AGENDA
La Vergne Planning Commission
February 27, 2024 at 6:00 PM

Item Title: Site Plan - Blair Ridge - 141 Dwelling Units in 26 Buildings. Requested by SEC, Inc. Property located on Blair Road (Tax Map 29, Parcel 21.01). R-3 (High Density Residential) Zoning District. Property owned by 303B Partners. DEFERRED

Summary: On behalf of their client, SEC is requesting approval of the site plan for Blair Ridge, a townhome community.

C-1.0

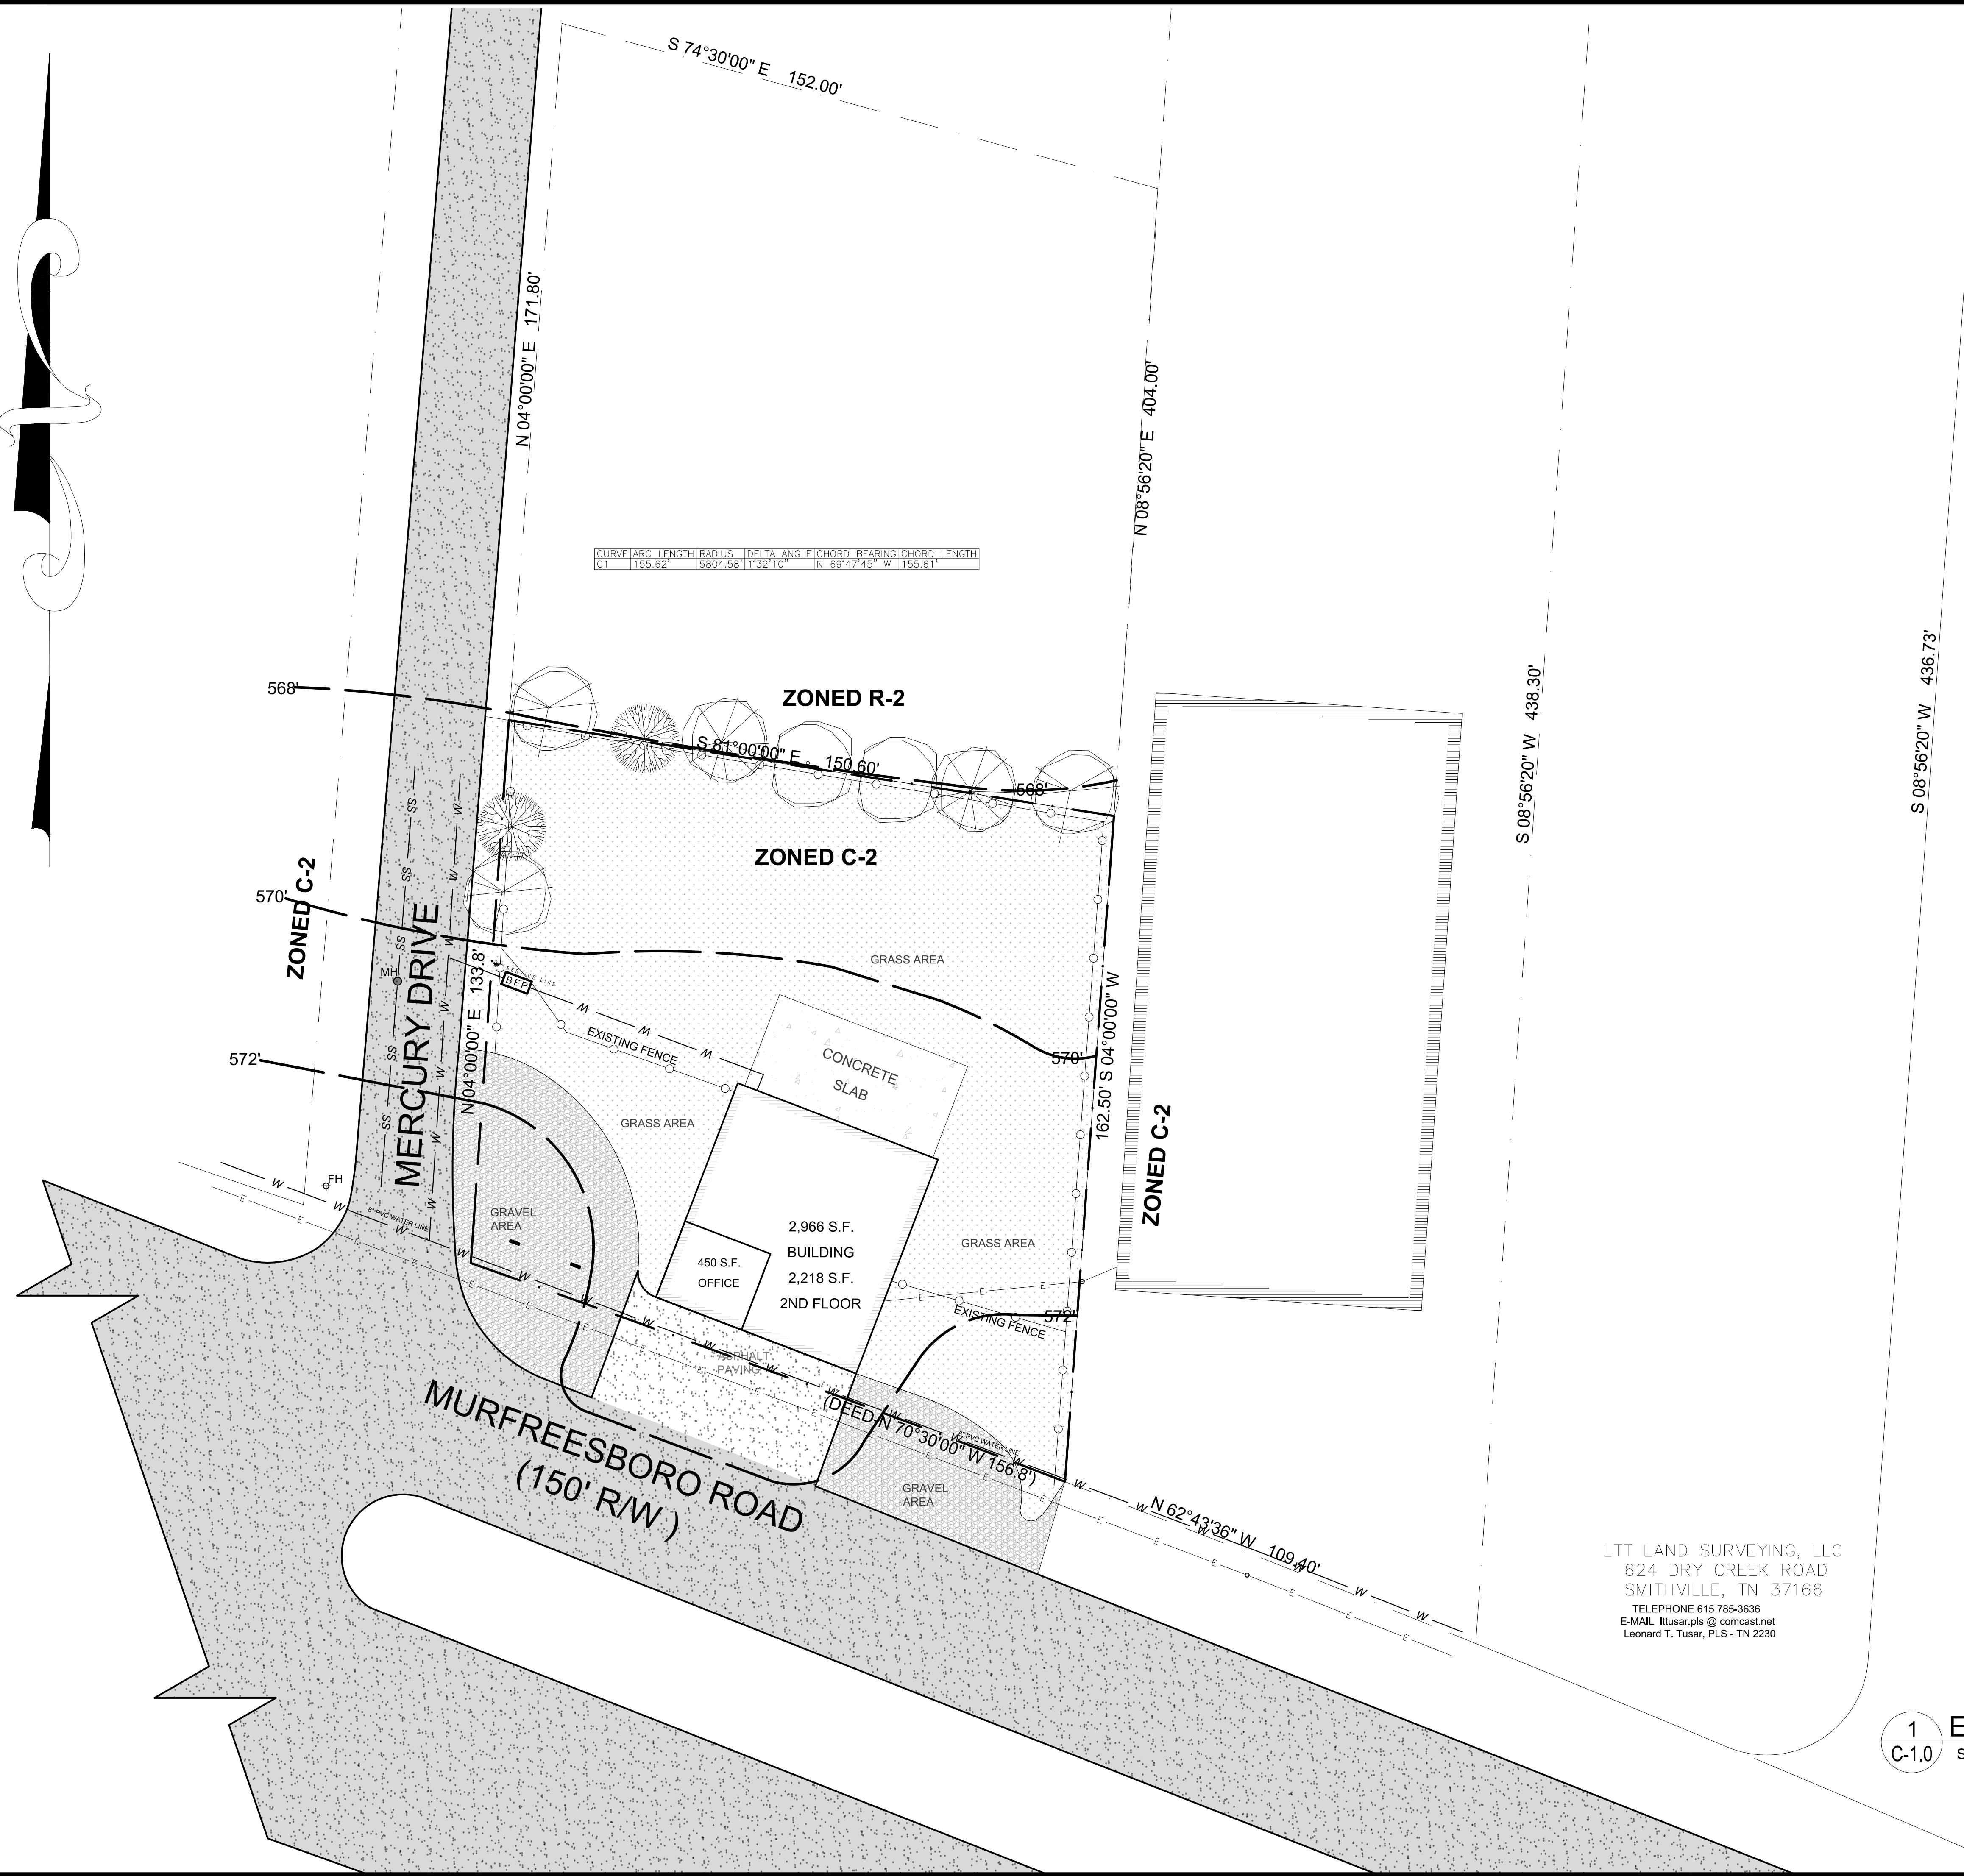
1. (Sheet C-1.0) The Existing Conditions plan does not show the Existing Conditions. This causes confusion regarding the focus of the submittal. Please update the Existing Conditions sheet so that the focus of the submittal is clear.

4. (Sheet C-1.0 or C-2.0) Show dimensions of concrete slab on the north side of the building.
5. (C-3.0) Provide spot elevation at curb cut into detention basin.

1 Proposed Site Plan
C-2.0 SCALE: 1" = 10'

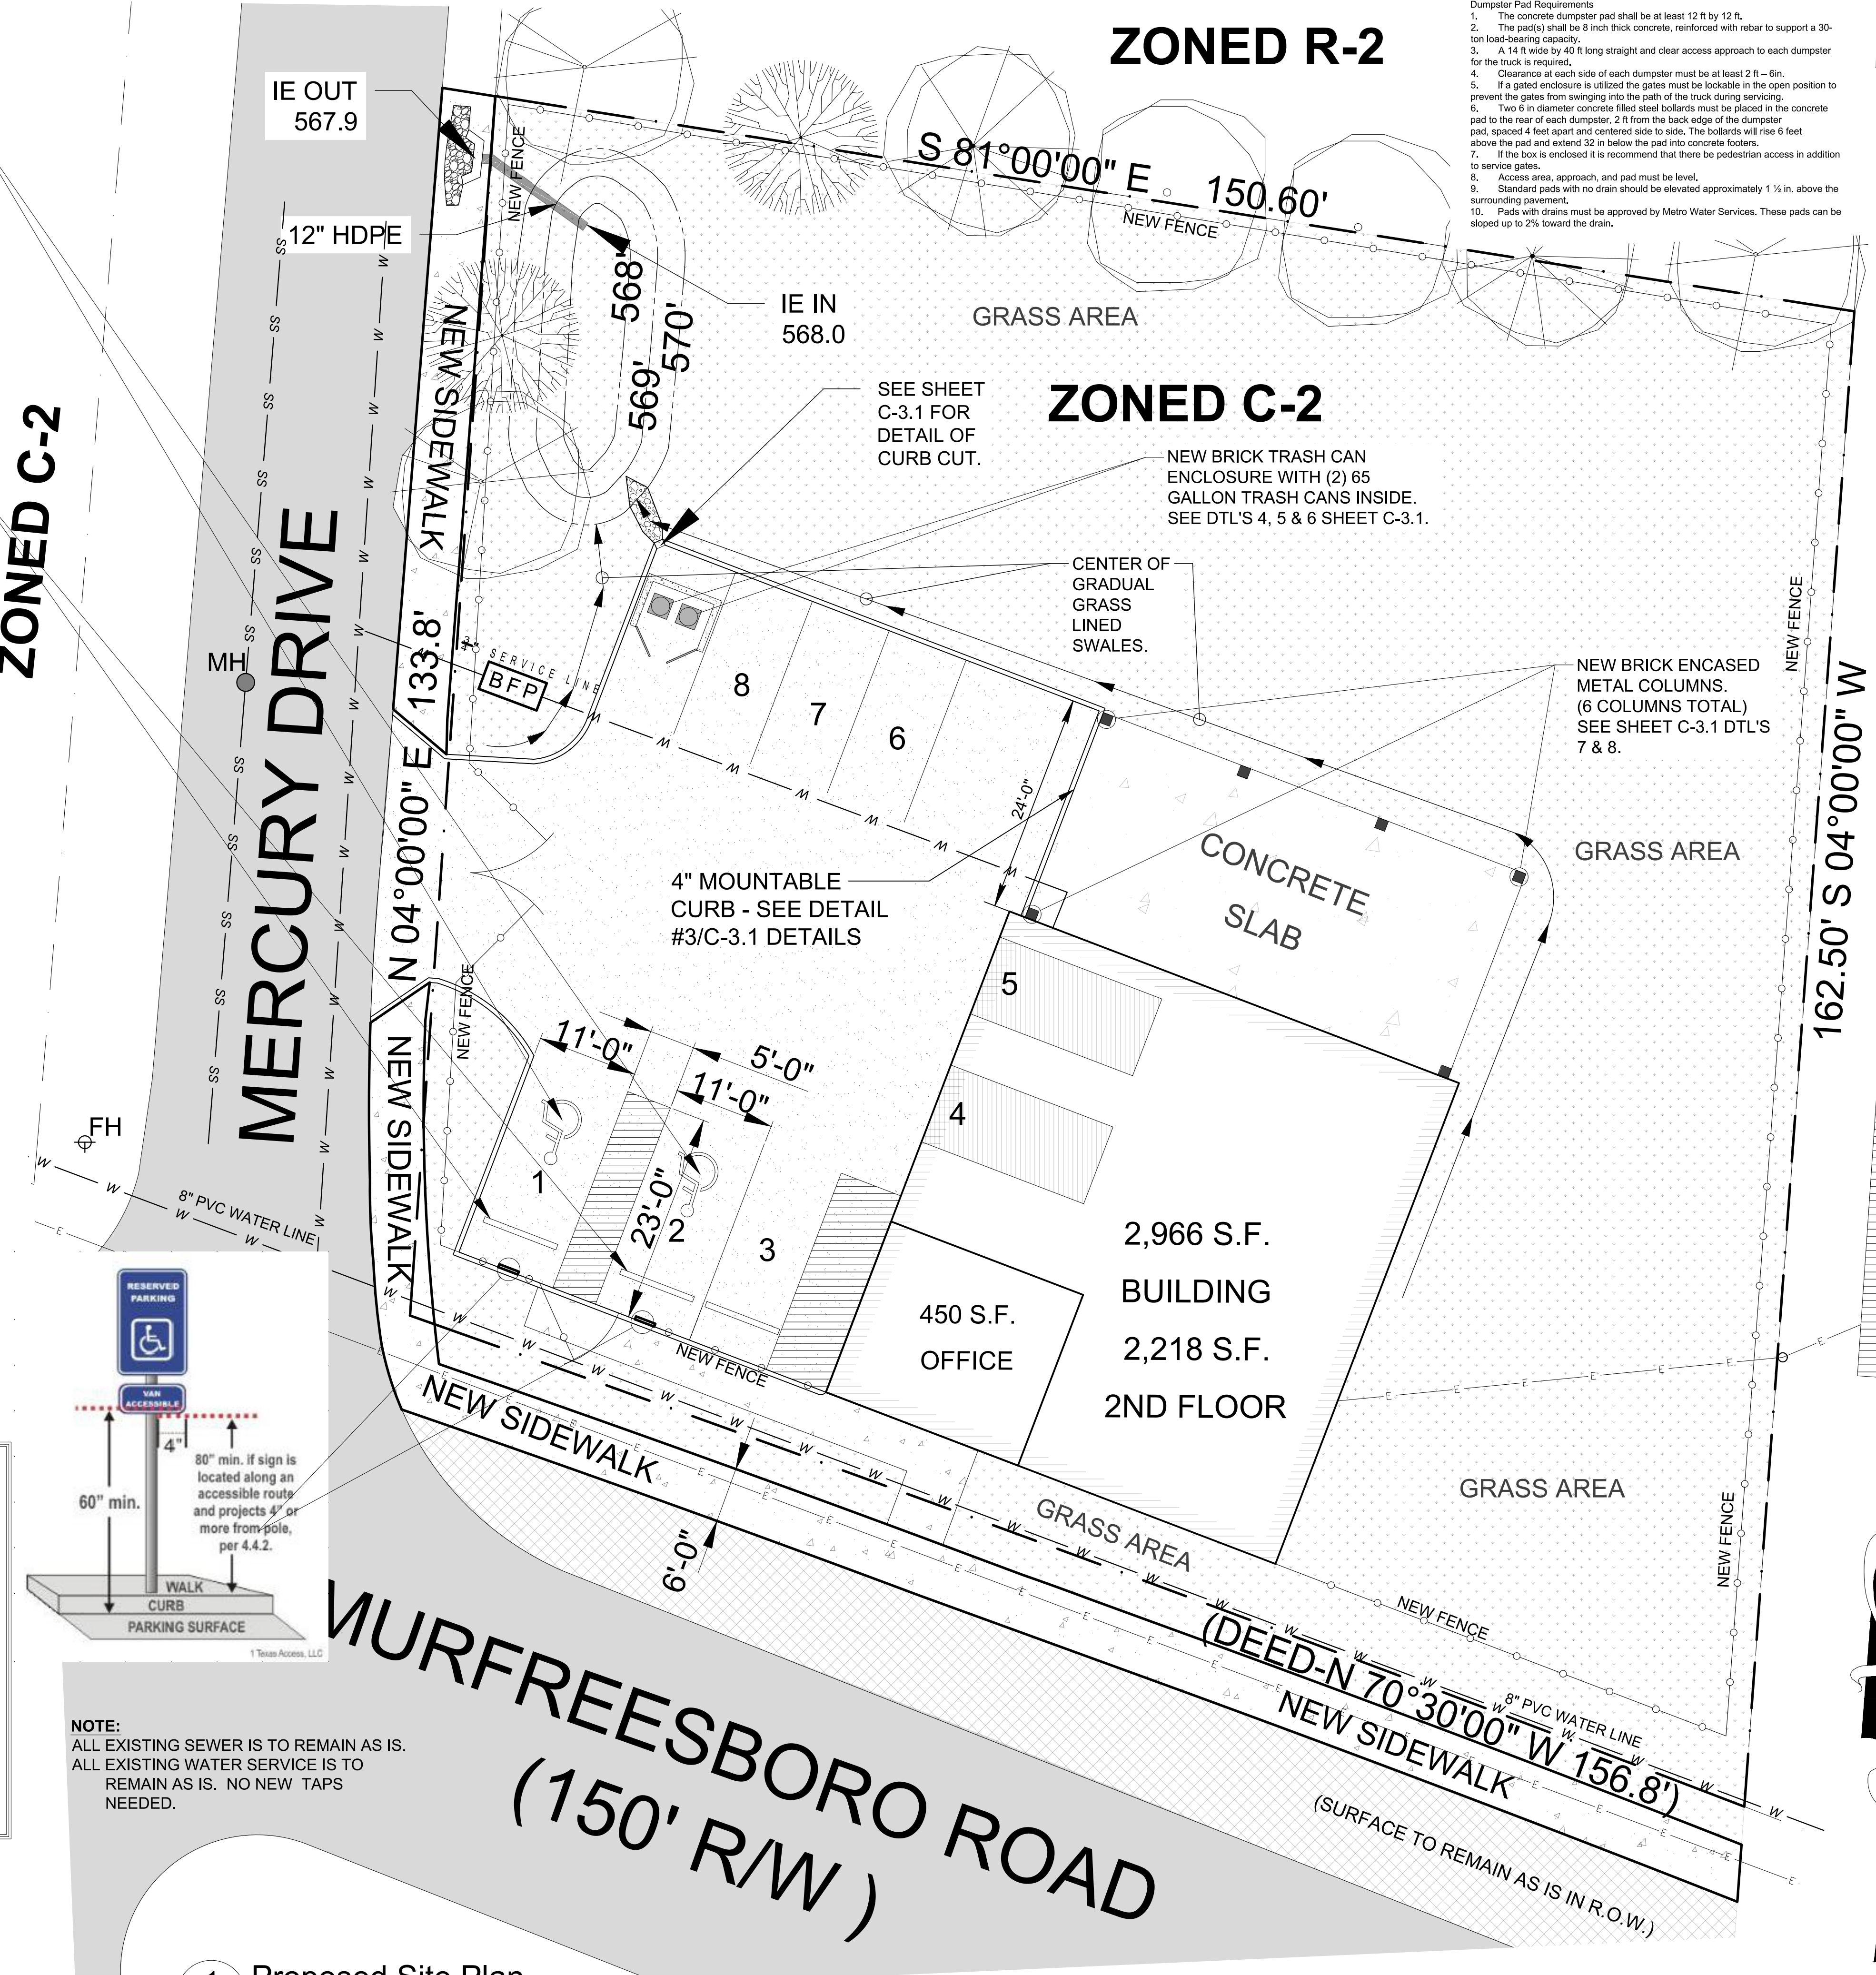
2. (Sheet C-2.0) Show and dimension the proposed architectural addition which is intended to be shown on sheets A-1.0 and A-1.1.
3. (Sheet C-2.0) Parking space #1 does match what was already built. Please revise drawing to match what is intended.

8. (C-0.0) Add note regarding the flood zone based on the May 2023 FIRM mapping from FEMA.
9. (C-2.0) Stormwater Department would prefer that the garbage cans not be located immediately adjacent to the curb cut into the detention basin as this maximizes the potential for illicit discharge.
